WG Tdoc	Spec	CR	R	Cat	Rel	Curr Ver	Title	Work Item
R5s050136	34.123-3	1285		B	Rel-5	5.0.0	Addition of WI-012 NAS test case 9.4.5.4.6 to NAS ATS V5.0.0	TEI
R5s050170	34.123-3	1286		B	Rel-5	5.0.0	Addition of NAS P4 test case 12.4.1.4c Proc1 to NAS ATS V5.0.0	TEI
R5s050173	34.123-3	1287		B	Rel-5	5.0.0	Revision and Addition of WI-10 (P2) test cases 6.2.2.2 to IR_U ATS v5.0.0	TEI
R5s050179	34.123-3	1331		B	Rel-5	5.0.0	Revision of RRC WI-14 test case 8.2.3.30 to RRC ATS v5.0.0	TEI
R5s050199	34.123-3	1332		B	Rel-5	5.0.0	Addition of RRC WI-014 test case 8.2.4.36 to RRC ATS V5.0.0 (Revision of R5s050161)	TEI

CHANGE REQUEST

Title:	# Addition of NAS WI 12 test case 12.3.2.7 to NAS ATS V5.0.0		
Source:	# 3GPP TSG RAN WG5 (Testing)		
Work item code:	# N/A	Date:	# 01/04/05
Category:	# B	Release:	# Rel-5
	Use <u>one</u> of the following categories:		Use <u>one</u> of the following releases:
	F (correction)		2 (GSM Phase 2)
	A (corresponds to a correction in an earlier release)		R96 (Release 1996)
	B (addition of feature),		R97 (Release 1997)
	C (functional modification of feature)		R98 (Release 1998)
	D (editorial modification)		R99 (Release 1999)
	Detailed explanations of the above categories

Label WA#RRC4902

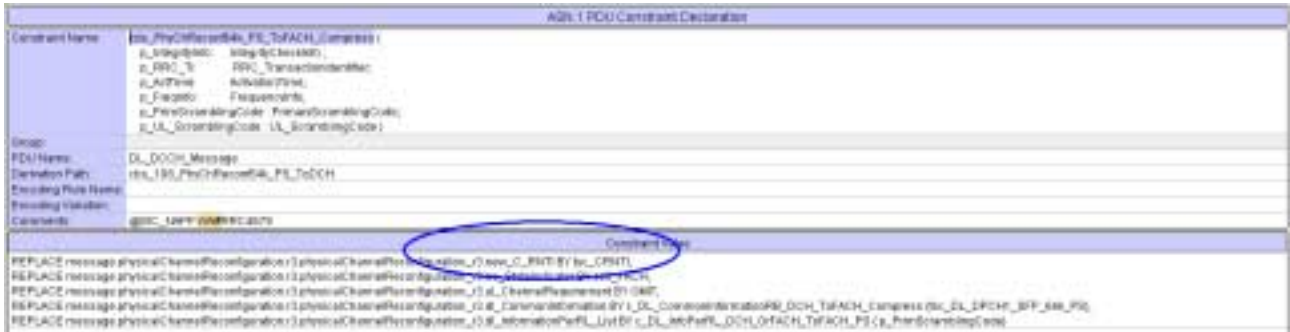
Reason for change The TGPS Status must be set to Activate according to the prose.

Summary of change Created new constraint .
